CITY OF ALBUQUERQUE

RE: 9519 Lyndale Lane NW
Grading and Drainage Plan
Engineer's Stamp Date: 08/04/21
Hydrology File: C13D027F

Based upon the information provided in your submittal received 08/09/2021, the Grading & Drainage Plan **is not** approved for Grading Permit. The following comments need to be addressed for approval of the above referenced project:

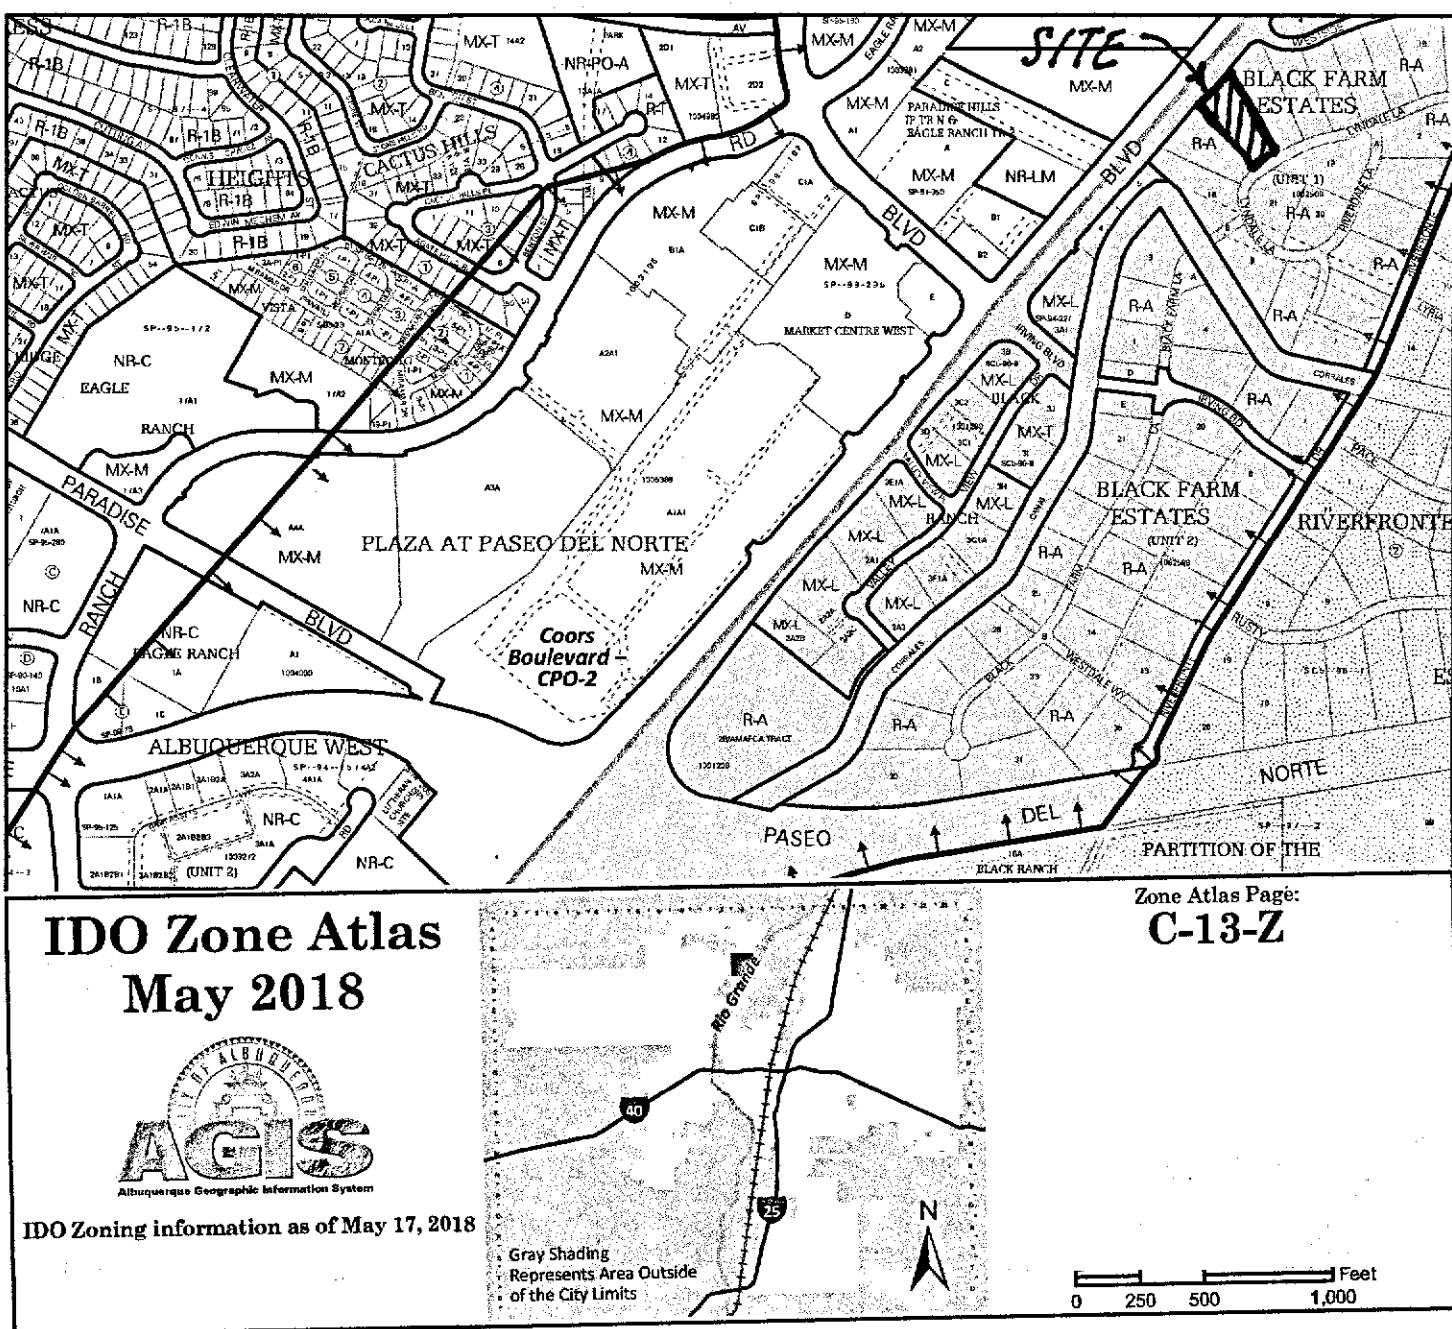
1. This lot is part of the Drainage Report for Black Farms by Tierra West dated June 2004 (C13D027). This drainage report states that each lot is required to follow the Flat Grading Scheme of the DPM. Please note that you must follow the current DPM Article 6-5 Valley Drainage Criteria and pond the 100 year 10-day volume. Below are excerpt of the Drainage Report. According to the report for this lot, the required retention volume is 0.21 AC-FT or 9,147.6 CF of volume.
